**TOWN OF BROOKLYN
PLANNING AND ZONING COMMISSION
Agenda
Tuesday, March 19, 2024, 6:30 p.m.**

**Tetreault Building Company
Proposed Subdivision and Private Road
Revised Drainage Calculations**

ENGINEERING PLAN AND DRAINAGE REPORT REVIEW

The comments contained herein pertain to my review of plans (9 sheets) for the construction of a seven (7) lot conservation type of residential subdivision with private road. The plans were prepared by Archer Surveying, LLC, dated October 27, 2023 (revised January 15, 2024), for Tetreault Building Company.

Site Development Plan
"Road Profile"
Prepared For:
Tetreault Building Company
Wauregan Road - Route #205
Brooklyn, Connecticut

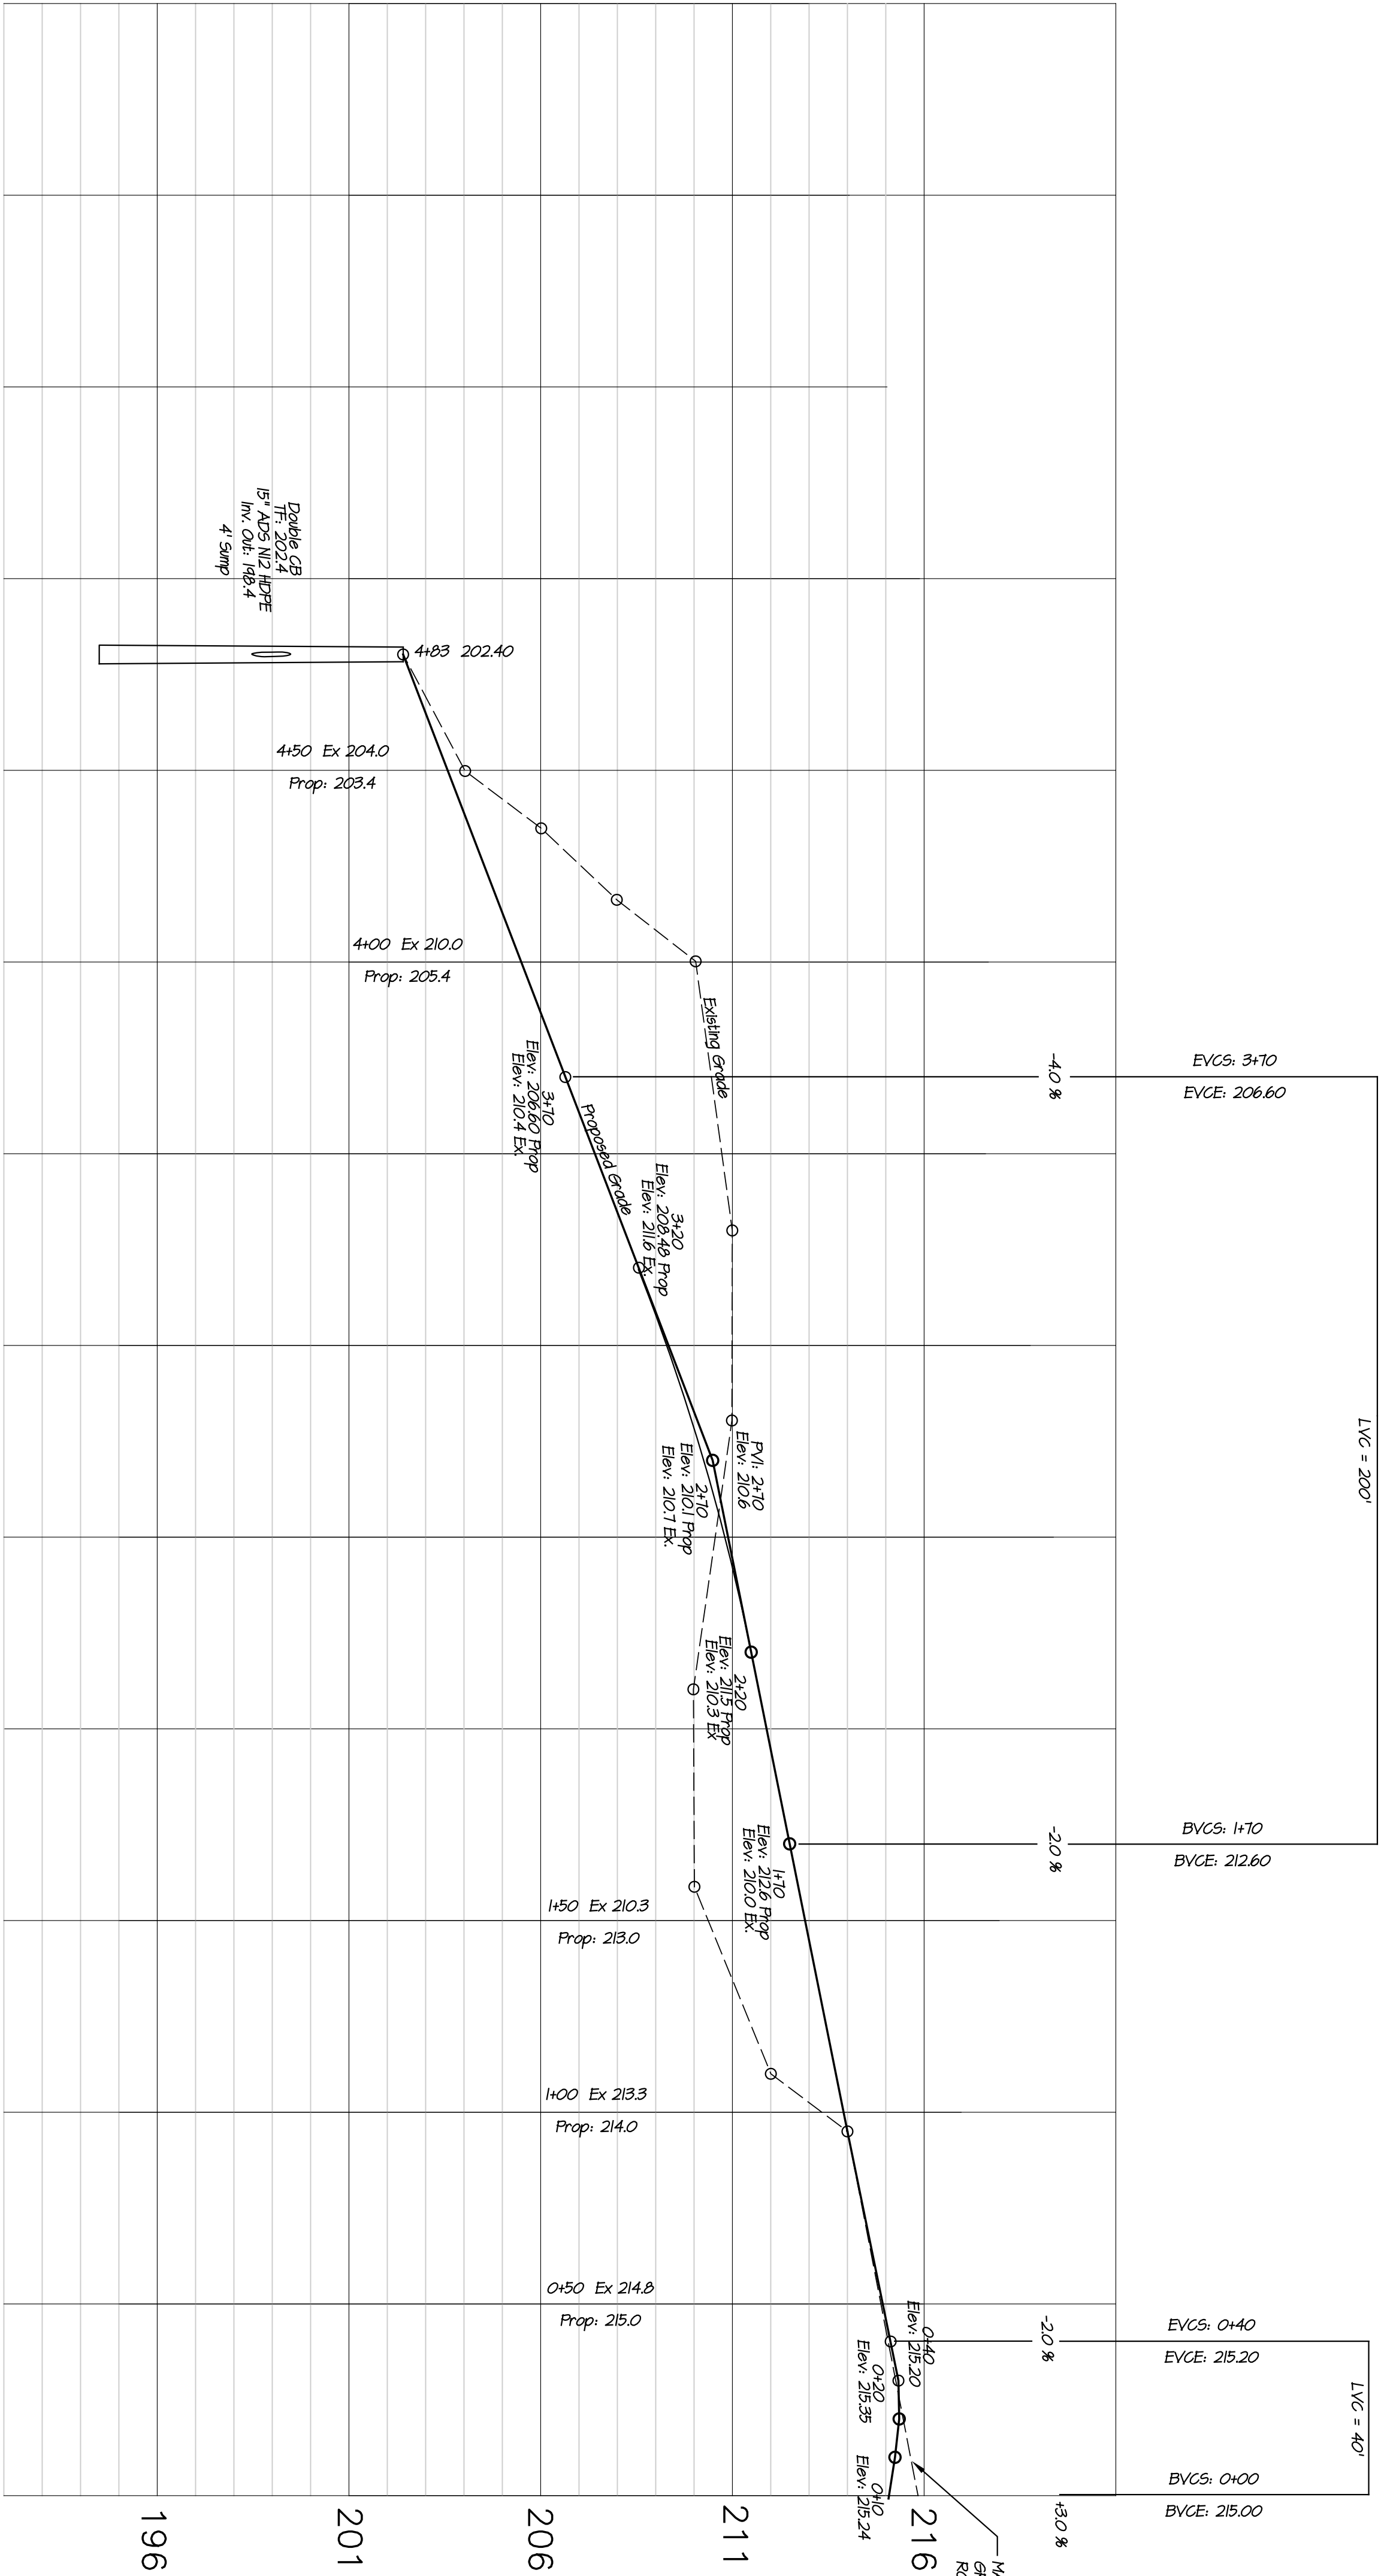
1. It is standard to show existing and proposed baseline elevations displayed on each side of vertical stationing lines, respectively, at the bottom of the profile grid. The elevations need to be added to the plan for every 25' at this location. **This private road has a simple vertical and horizontal design, 25' intervals are not needed for review or construction stake out, 50' intervals are sufficient**

2. Slopes expressed in decimal percentage (4 places) need to be added to the baseline profile line. **Not needed required for review or stake out. Information is provided to the tenth of a percent which is 3 decimal places.**

3. It is unclear what the unattached LVC = 200' and LVC = 40' notations refer to. Remove them and place the vertical curve designations (length, stations and elevations) attached to the BVC and EVC stations. **LVC refers to the length of vertical curve and compliments data shown for design and stake out purposes**

4. Add the location of the double catch basins to the profile with inverts, top of frame, etc. noted. **DONE**
